Required Modifications From Original LWE Supplied Current Shunt:

Revision History:

Title <b>Lightwave Electronics Current Shunt</b>		LIGO Laboratory California Institute of Technology Massachusetts Institute of Technology		LIGO	
Size: B	DCC Number: D040542	SCH / PCB Revision: A1	Engineer: RS Abbott	Date: 1/6 2005	Time: 12:00:58 PM
File: C:\Rich's Files\MyCADfiles\PSL\ISS\Current_shunt\lwe_shunt_b.SchDoc			Sheet 1 of 1

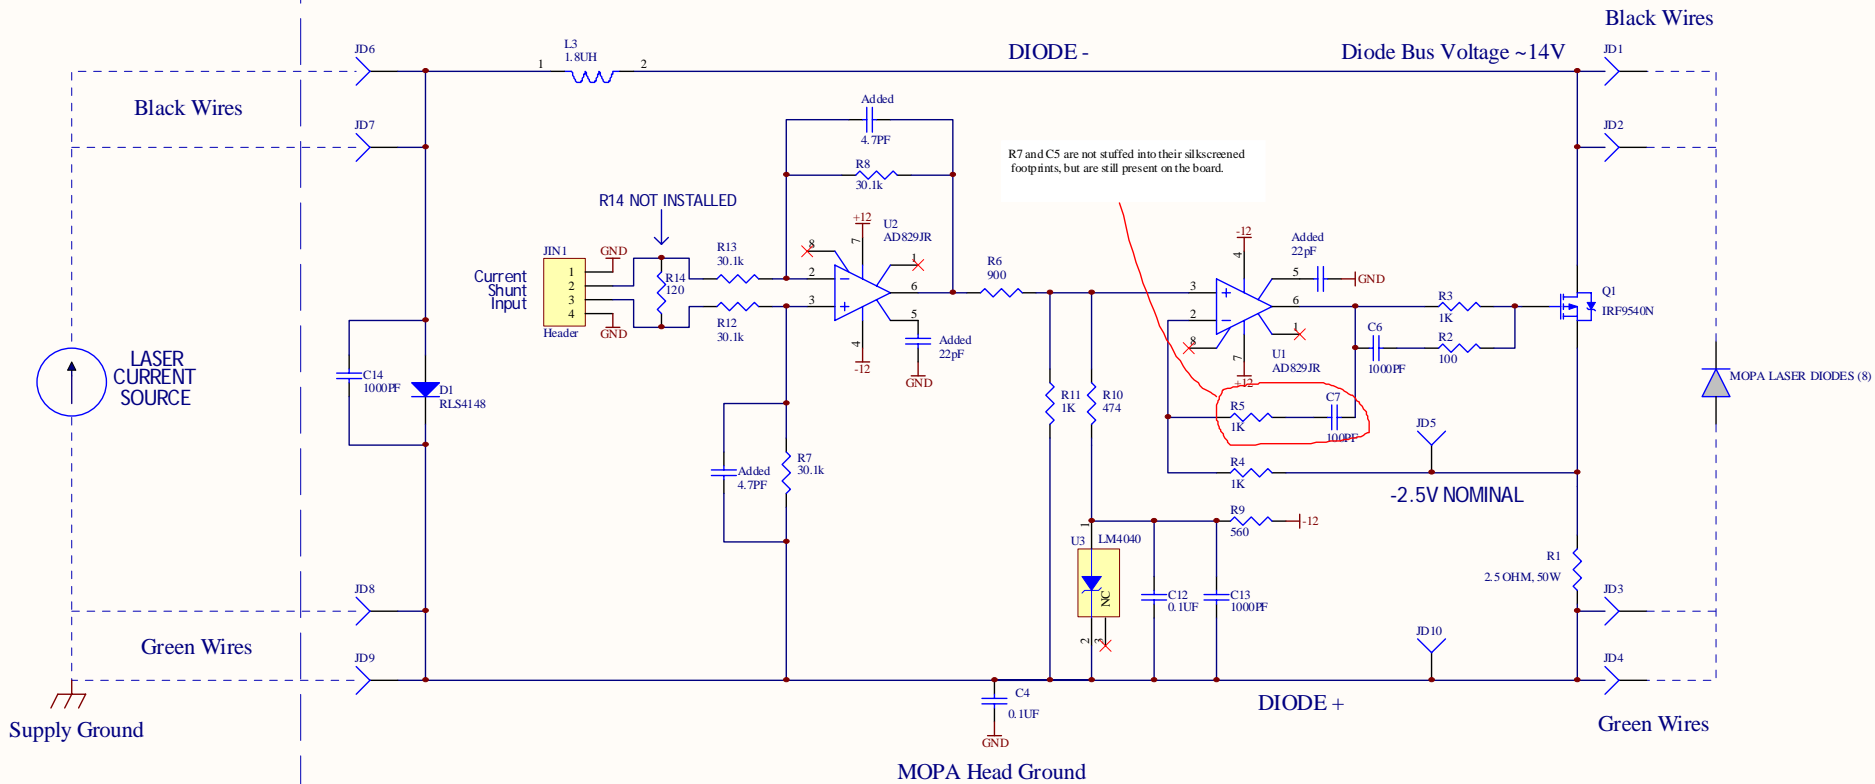
- Both op-amps must be replaced with AD-829 type amplifiers
- Compensation capacitors (22pF) must be added from pin 5 of the AD-849 chips to ground
- The power resistor (R1) is now mounted off the board and is changed to a 2.5 ohm, 50W
- R9 changes from 2k to 560 ohms
- R7 and R8 are bypassed with 4.7pF
- R14 is removed

- Compensation capacitors on pin 5 of each amp were increased from 15pF to 22pF to stop oscillations.
- Corrected labeling errors on Green and Black wires
- Added notes explaining that the PCB pads labeled "R5" and "C7" are not stuffed in their original silkscreened footprints, but bridged between R4 and C6.
